**EXEMPTION FORM
ENGINEERING DEPARTMENT**

Request for exemption received from: Chapel Hill Kehillah Church, Mr. Lee Nackman, 1200 Mason Farm Road, Chapel Hill, NC 27514, Ph: (919)942-8914

Type of exemption requested: TRAFFIC IMPACT ANALYSIS (TIA)

Chapel Hill Kehillah Parking Lot

Chapel Hill Kehillah
	Buildings
	UNC Land
	Average Daily Traffic (ADT) 2003 DOT Data

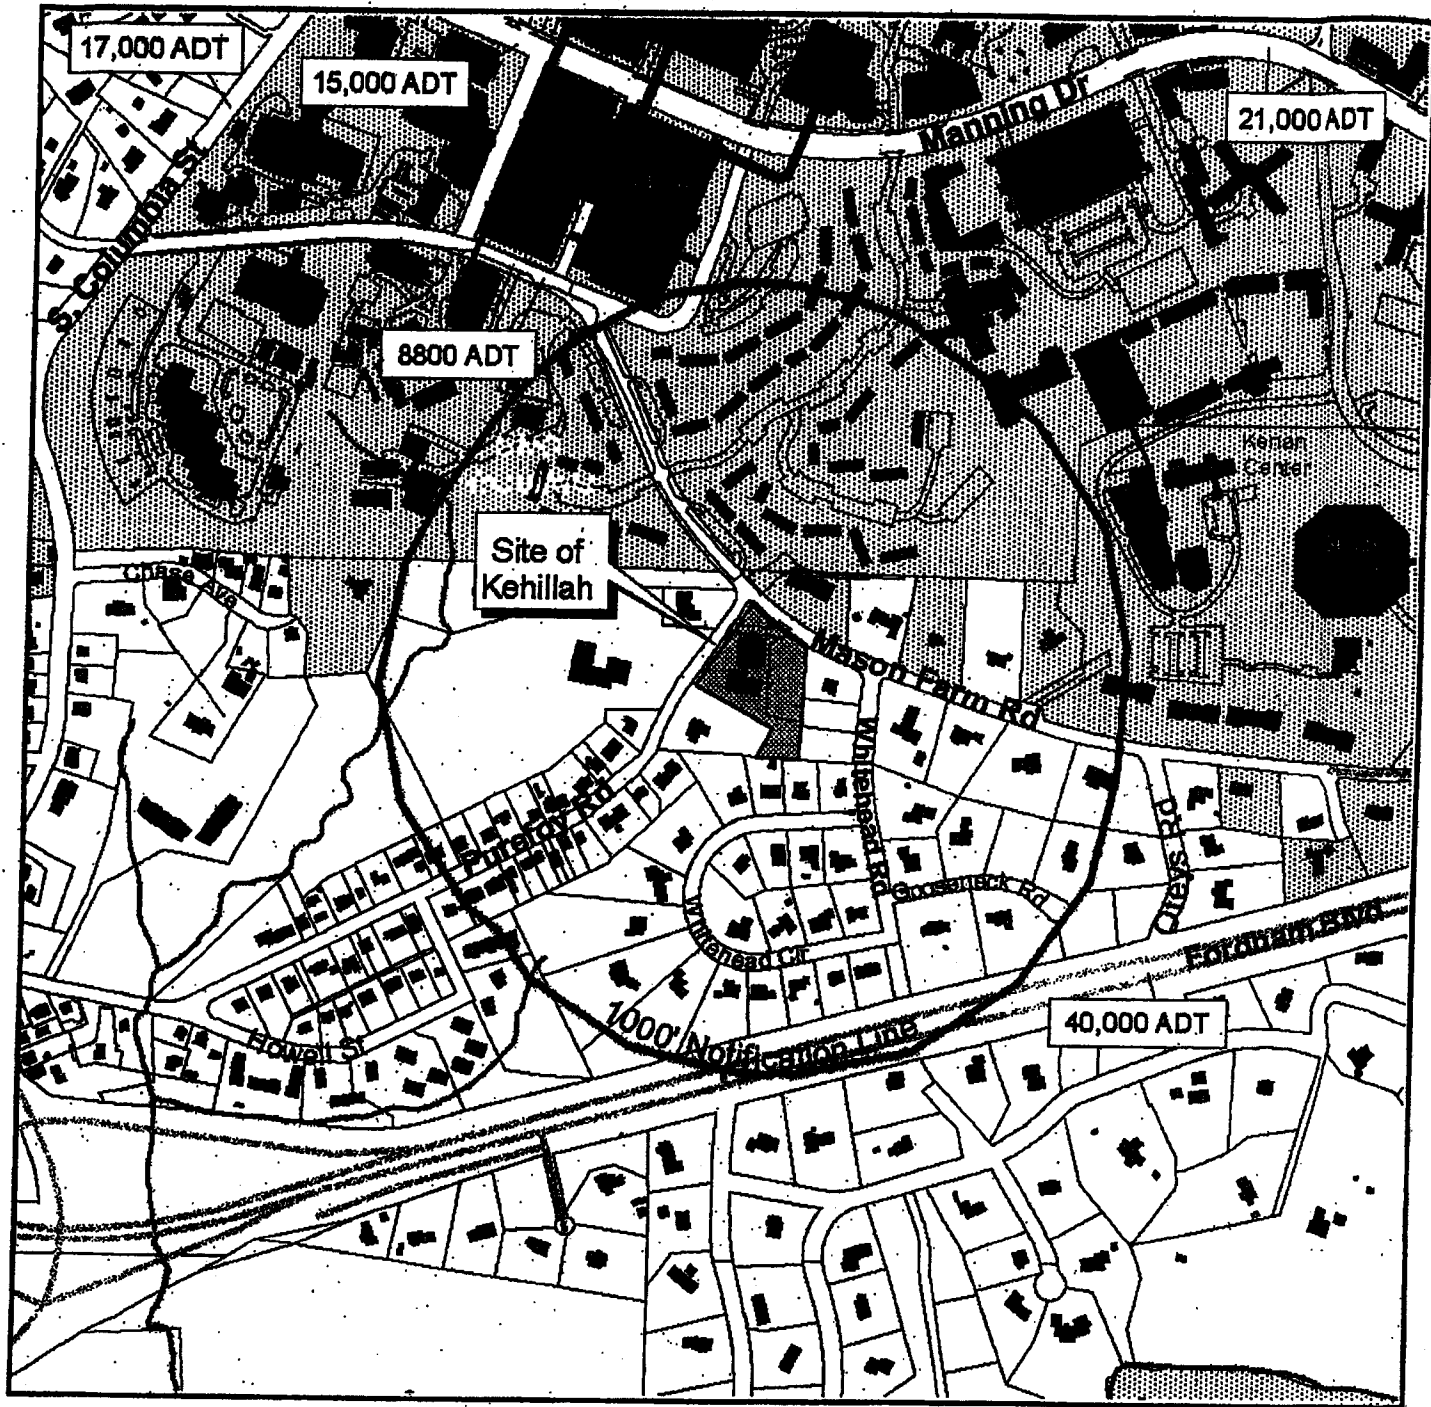
- a) Proposed lease of 50 existing parking spaces (Total existing parking spaces: 100) are expected to develop 200 vehicles per day (4 trips per day per parking space).
- b) No new access proposed to the parking lot and the existing access is sufficient enough to handle the additional trips generated by the leased spaces during day time.
- c) We believe that the impact on the surrounding street network by the additional trips is not significant.
- d) Meets the Town TIA Guidelines for an Exemption.

Based upon the attached request for exemption and supporting information, we recommend that the Town Manager approve an exemption for:
